Bladon Village Sir Winston Churchill Memorial Hall trustees oppose the Botley West Solar Farm. It is inappropriate to the location and we urge PINS to direct the developer towards the alternative sites originally considered.

Bladon Village Sir Winston Churchill Memorial Hall's Relevant Representation – Botley West Solar Farm

ANNEX C

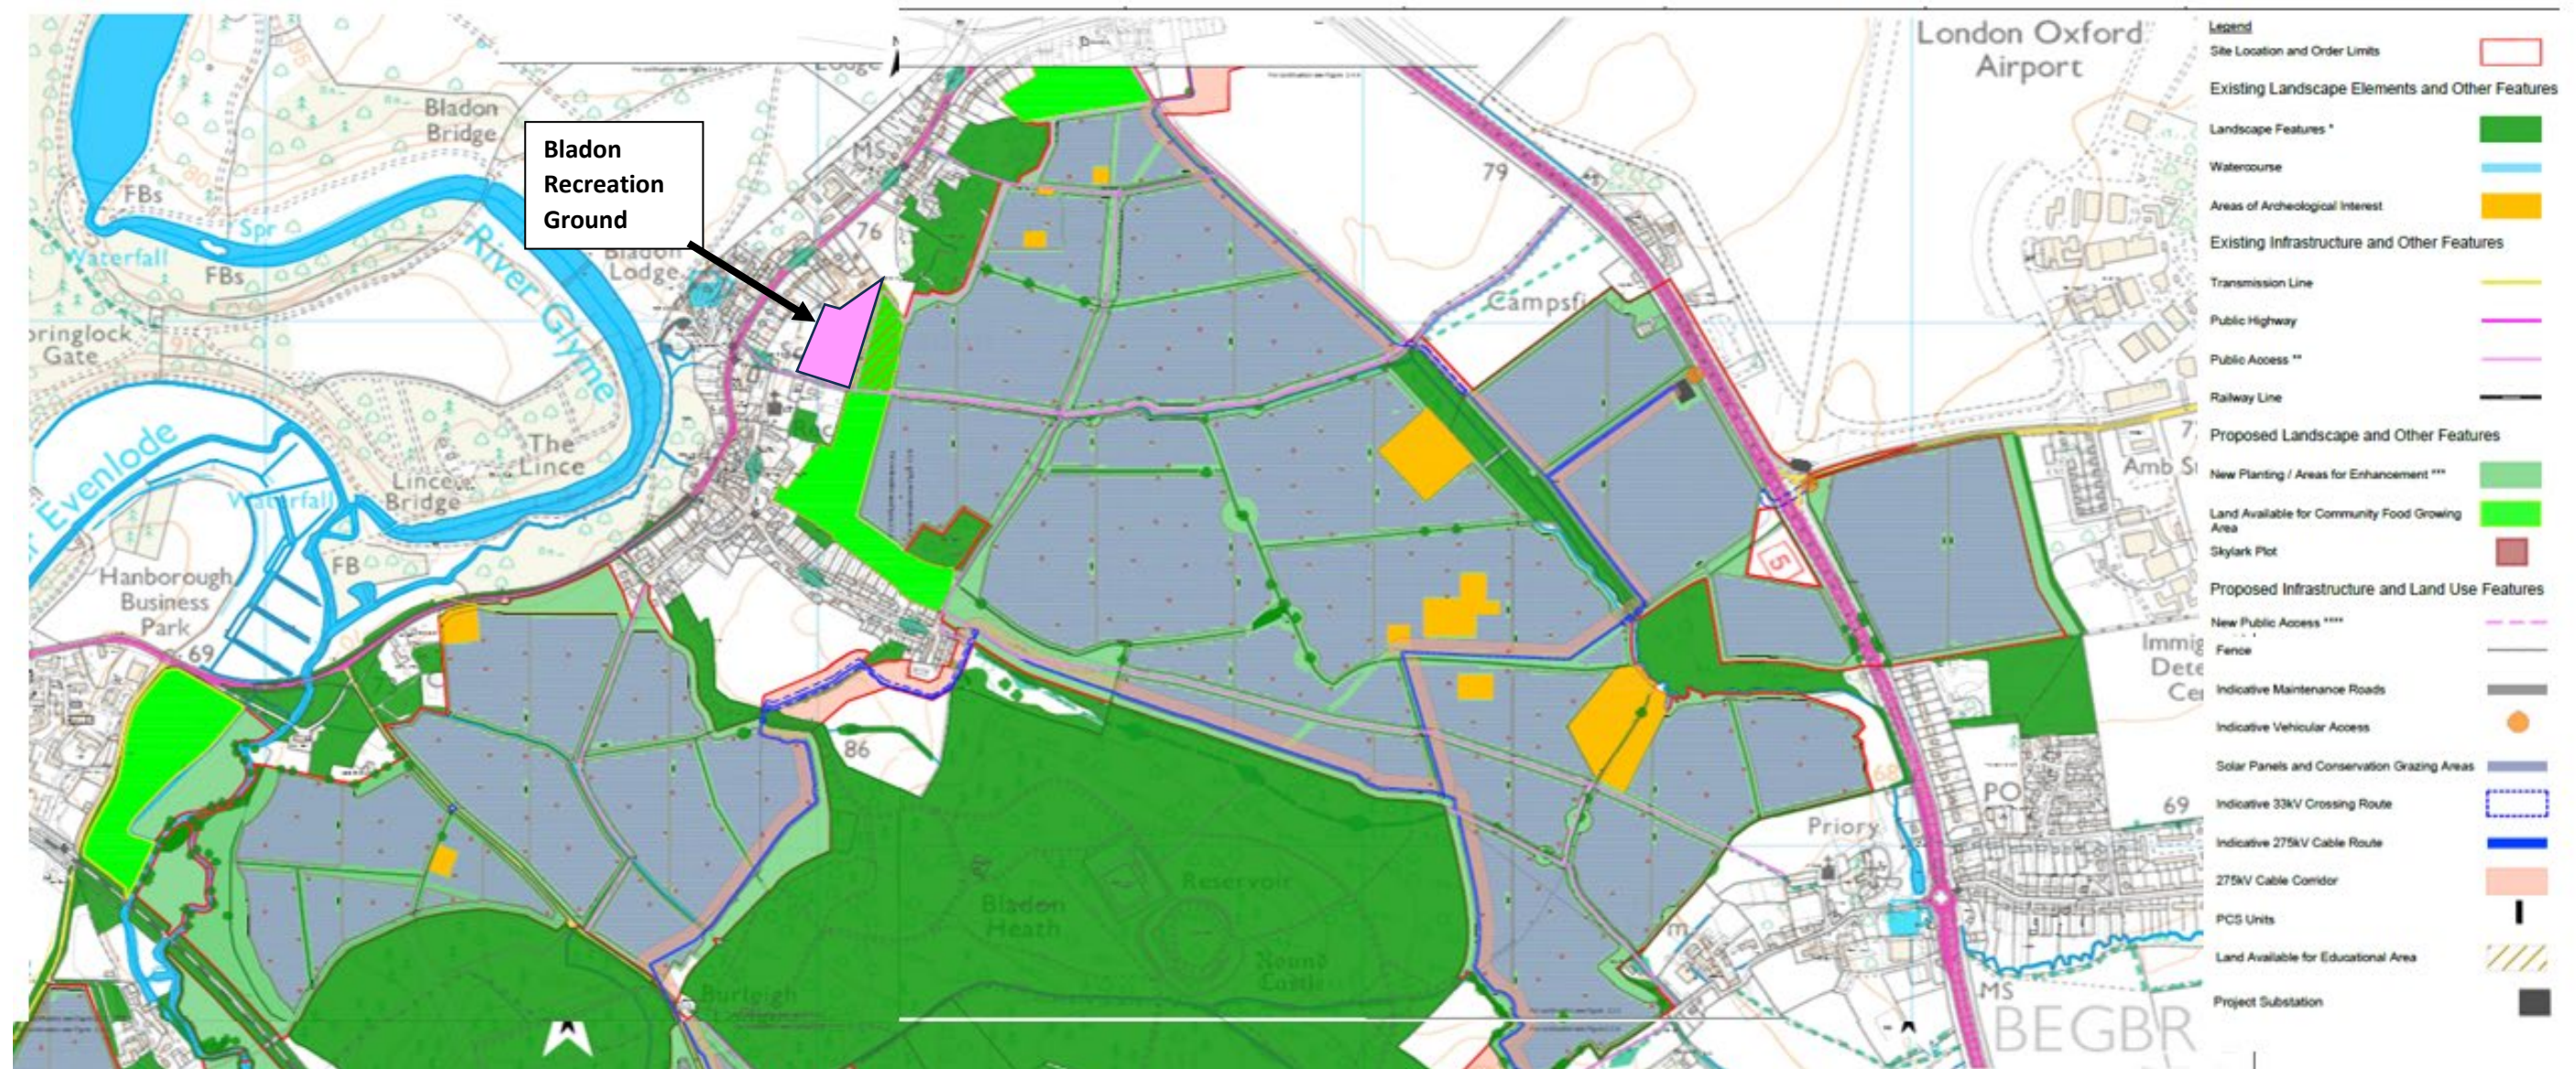
- 2.1 It is proposed that fencing will be erected adjacent to all existing and proposed PRow's within the development. This fencing will create a corridor effect along the PRow's.

- Footpaths Cross-field/other 1m
 - Footpaths Field-edge 1.5m
 - Bridleways Cross-field/other 2m
 - Bridleways Field-edge 3m
- 2.3 The creation of narrow corridors with 2.1m fencing either side will impact both the users of the network and the wildlife in the area.

- 2.4 There are concerns about personal safety when walking along the corridors that will be created by the high and continuous fencing.
- 2.5 There are hundreds of kilometres of PRow's throughout the development. There is over 5.8km of PRow's in the development area behind Bladon Village between Bladon Heath and the A44.

- 2.6 This 5.8km represents all of the PRow's available and easily accessible by Bladon residents.
- 2.7 Of the 5.8km of PRow, all but approximately 840m will be surrounded on both sides by solar panels and 2.1m fencing. The remaining 840m will have solar panels and fencing one side. This means that users of the PRow's around Bladon will have not any PRow's available to them that are not surrounded by a continuous view of solar panels and fencing. The only other option for recreational walking is within the grounds of Blenheim Palace.

- 2.9 BVHRC requests that development in the proximity of the PRow's is avoided and that if this is not possible then the width of the PRow's should include a considerable sized buffer so that amenity of the PRow's can be preserved.
